Robert Burger  
Sierta, LLC

Elliott Russell  
Colorado Division of Reclamation, Mining and Safety  
Department of Natural Resources  
1313 Sherman Street, Room 215  
Denver, CO 80203

**Re: Response to Deficiencies, MD-02, P-2014-003**

## Sierta Mineral Claims Block with Pad Locations

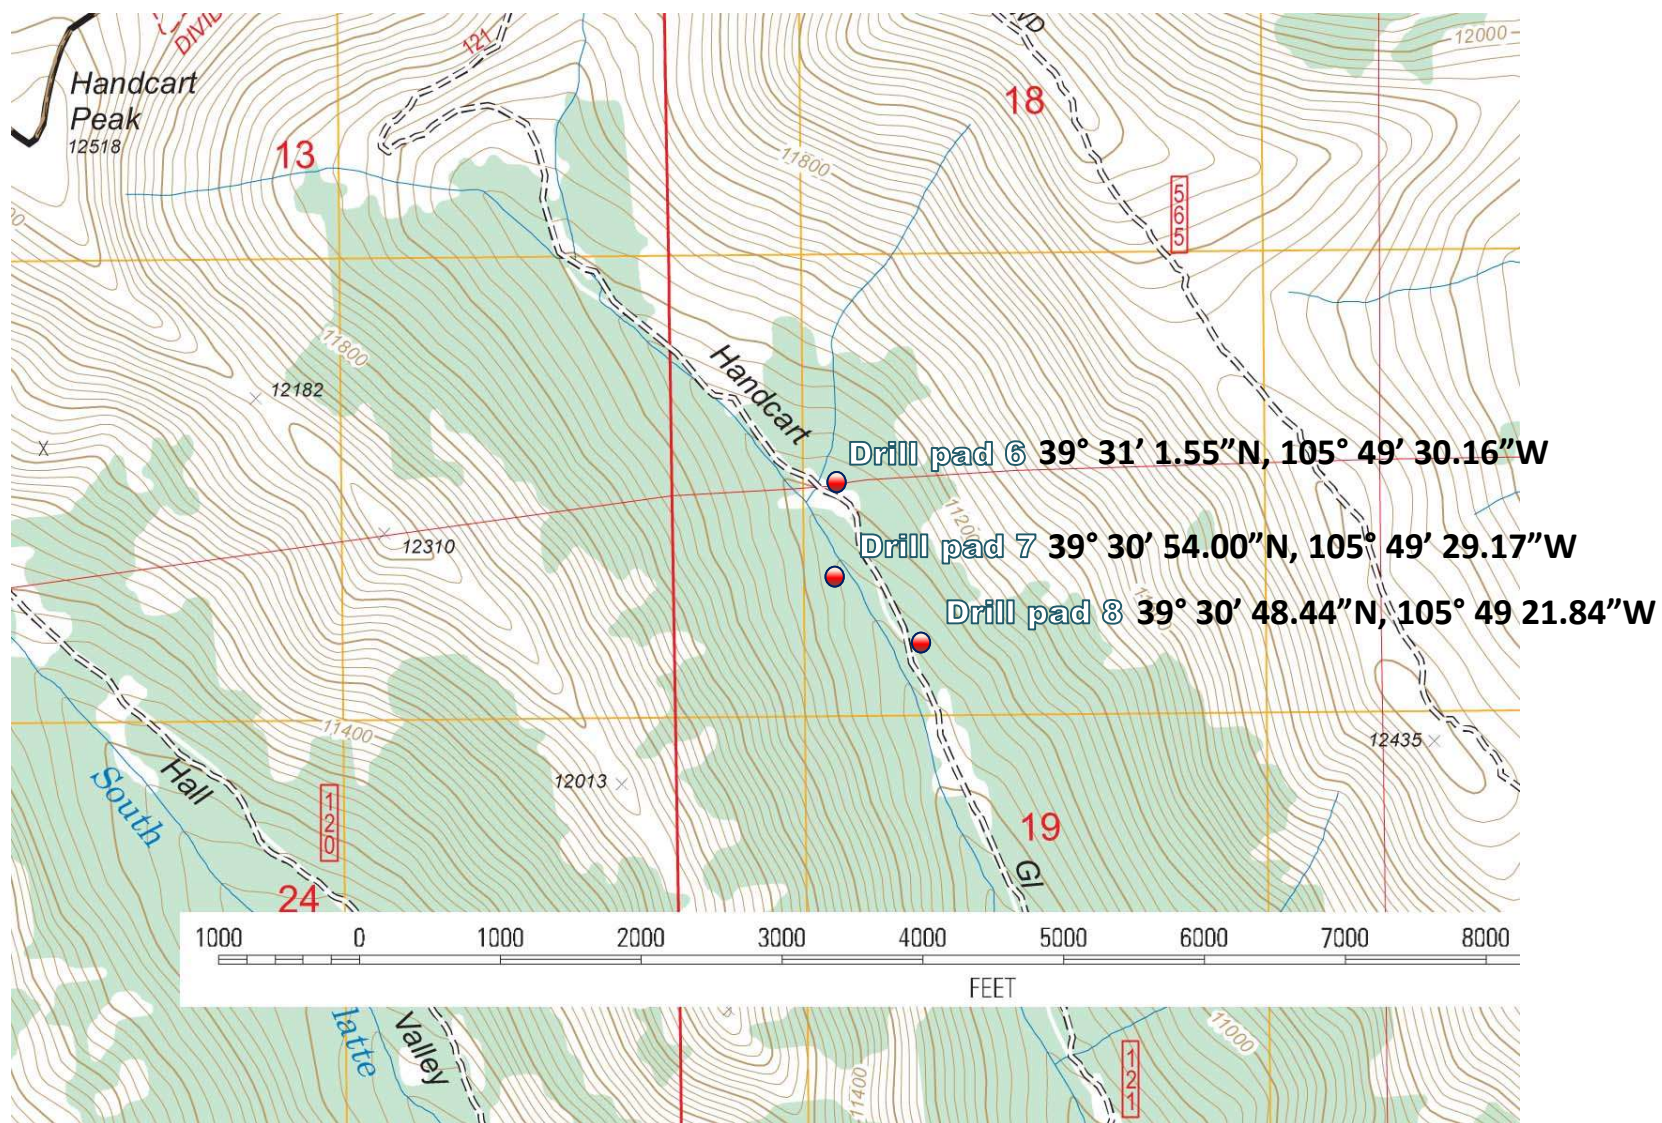
Item 2: Please see the attached revised map titled Sierta Mineral Claims Block with Pad Locations.

Item 4: The error for drill pads 7 and 8 was that they were marked as at 31'N where they were actually 30'N. The attached map includes the corrections with coordinates formatted in degrees, minutes, and seconds.

## Footprint of drill pad 7 and access road

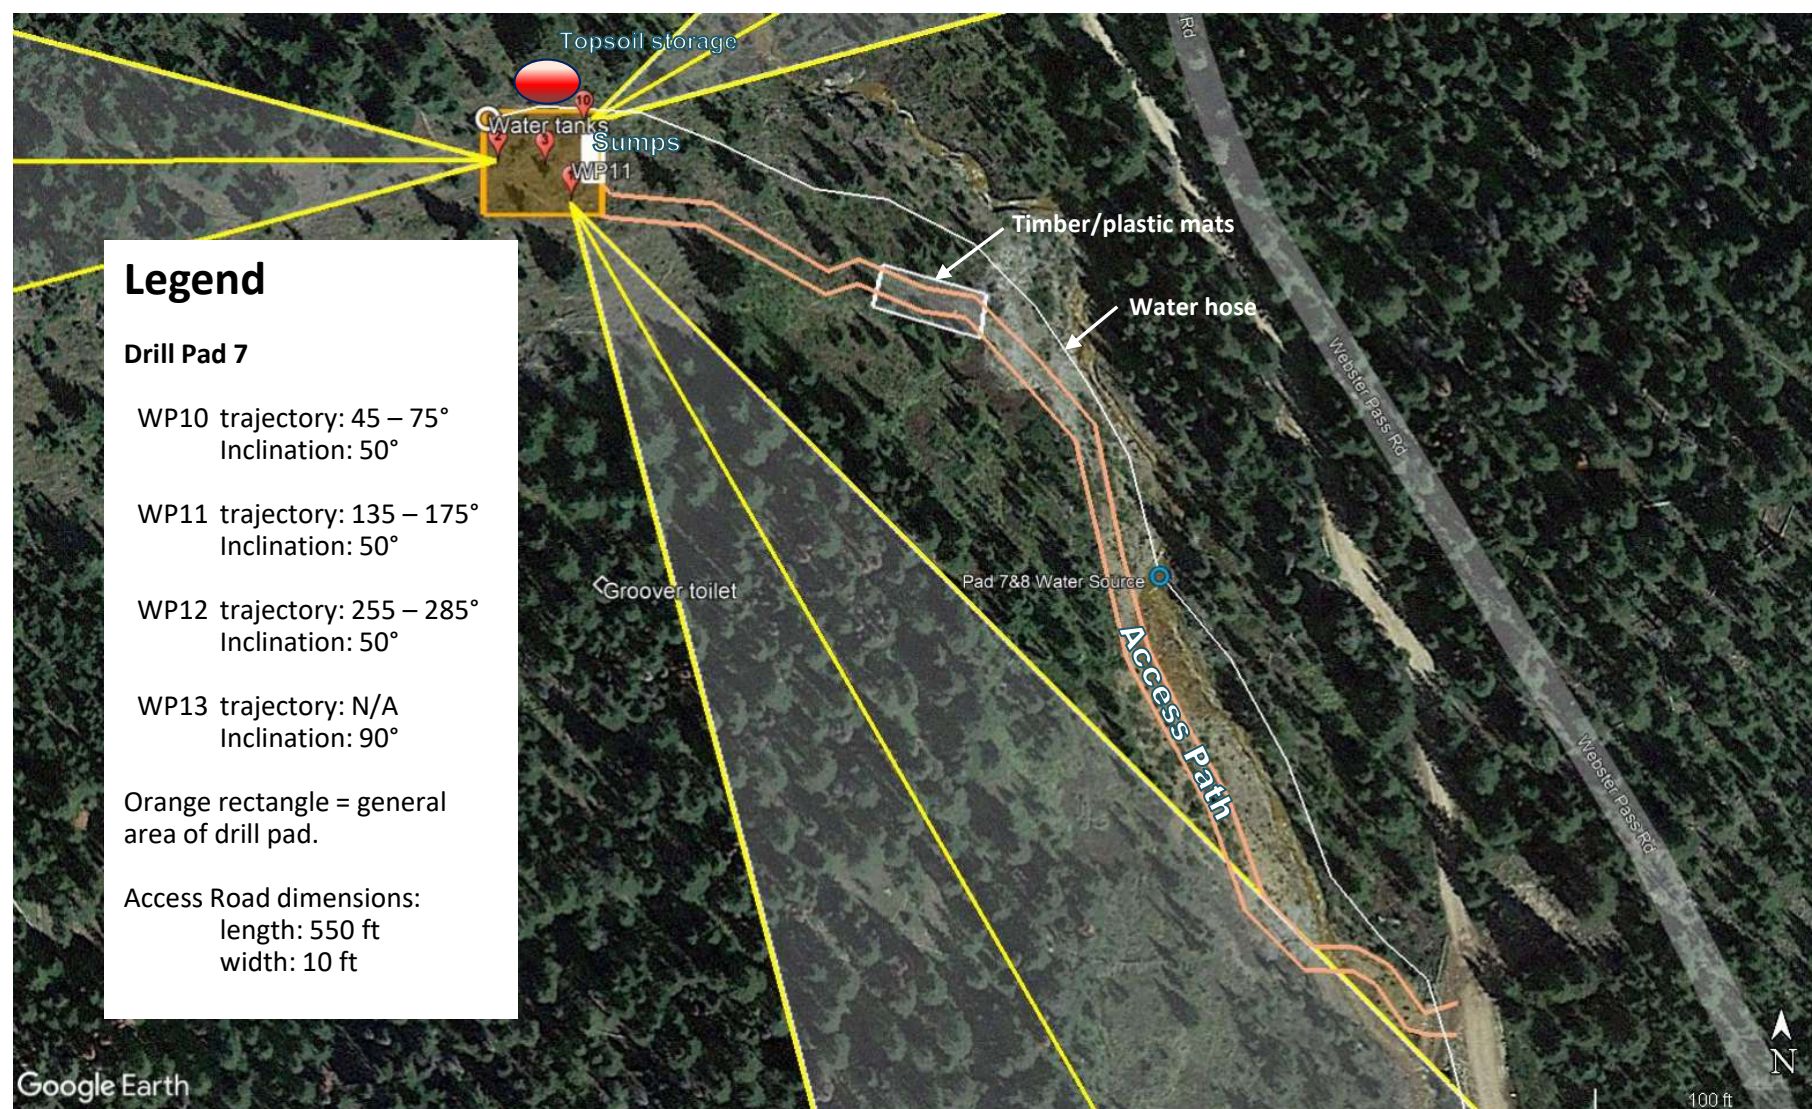
Item 5: Please see the updated map of Pad 7 with the entire access route to the pad. The access route to Pad 7 crosses Handcart Gulch where it flows across solid ferricrete. There is no significant loose sediment smaller than gravel size at this location that can be disturbed by the crossing and the stream is on the order of 3 to 5 feet wide. Also, Handcart Gulch flows across and/or upon Webster Pass Road—a road used regularly by 4WD and off-road vehicles—in three locations during the summer months. Based on these conditions, it is unlikely that access to Pad 7 by vehicles along the access route will affect surface water quality at, or downstream, from the stream crossing. If the Forest Service deems it necessary, Sierta will set a timber mat, or similar device over the stream at the crossing to prevent stream damage.

## Footprint of drill pad 8

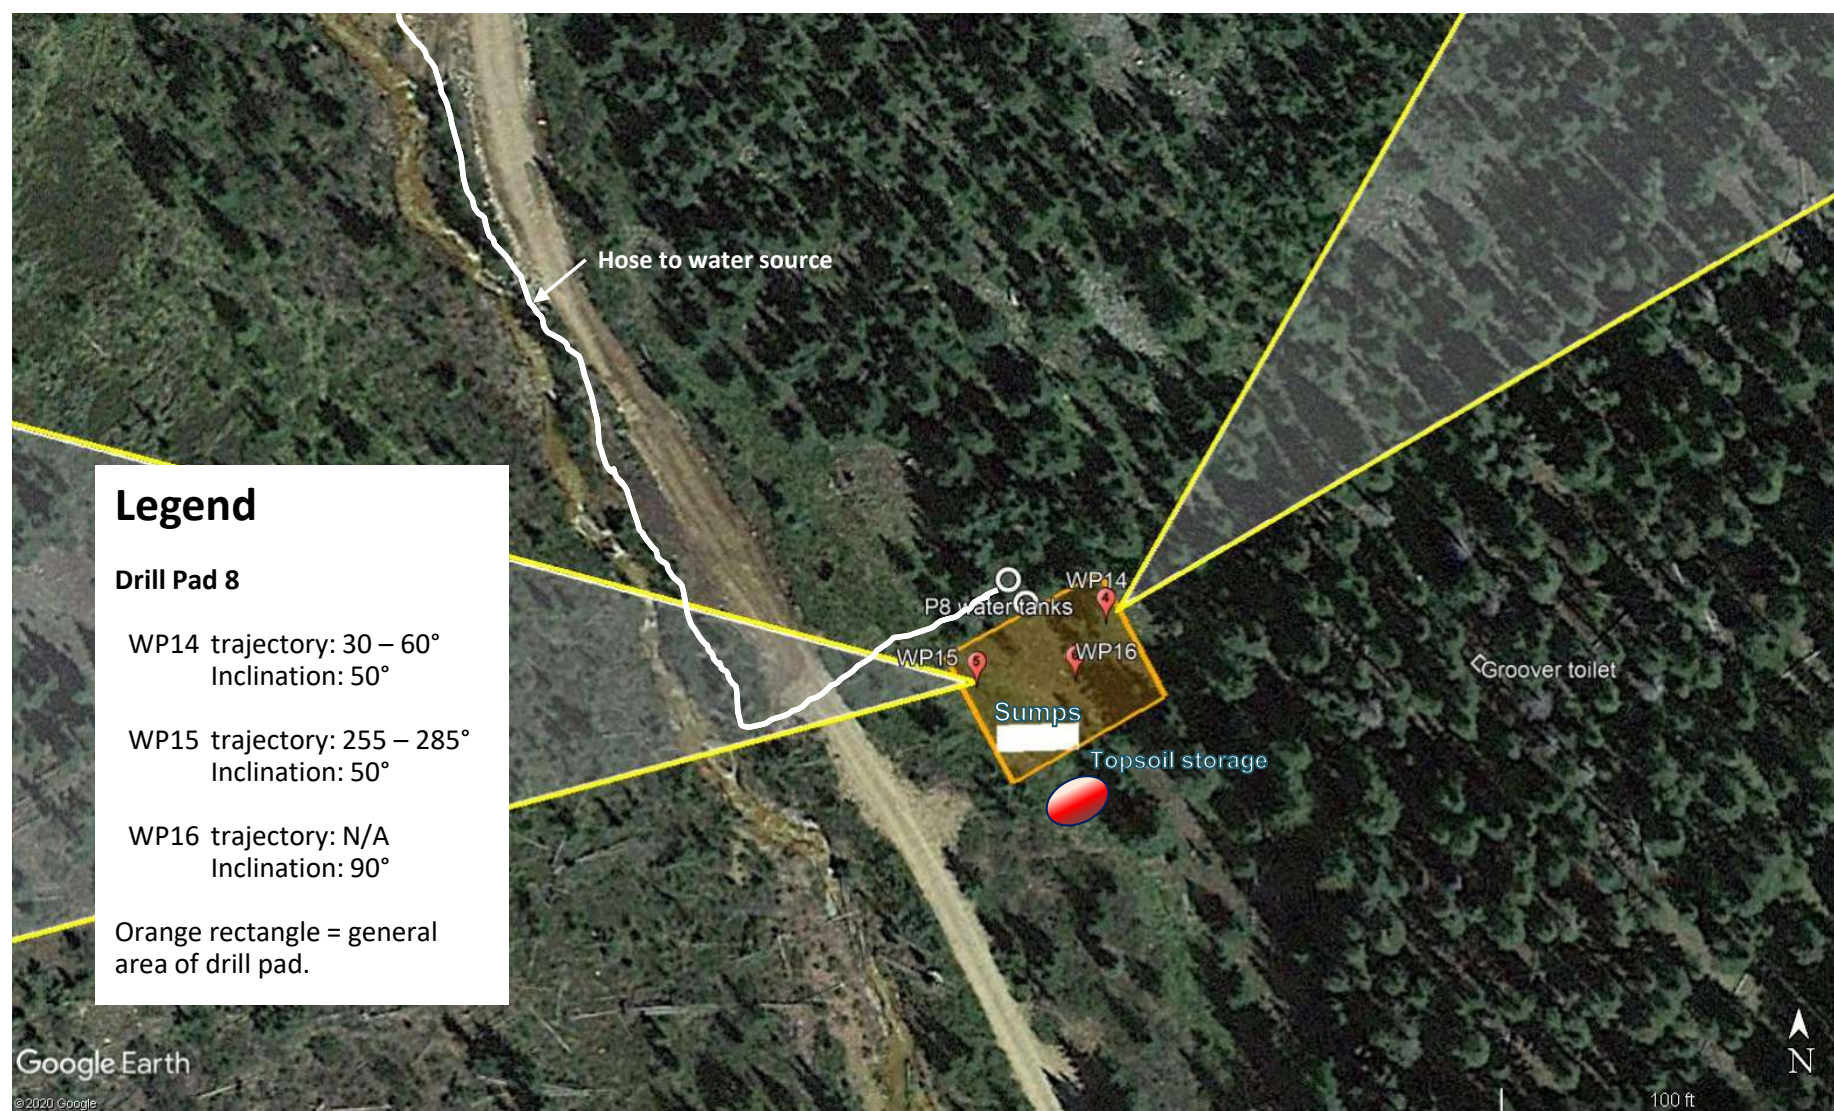
Item 6: See revised map titled Footprint of Drill Pad 8.
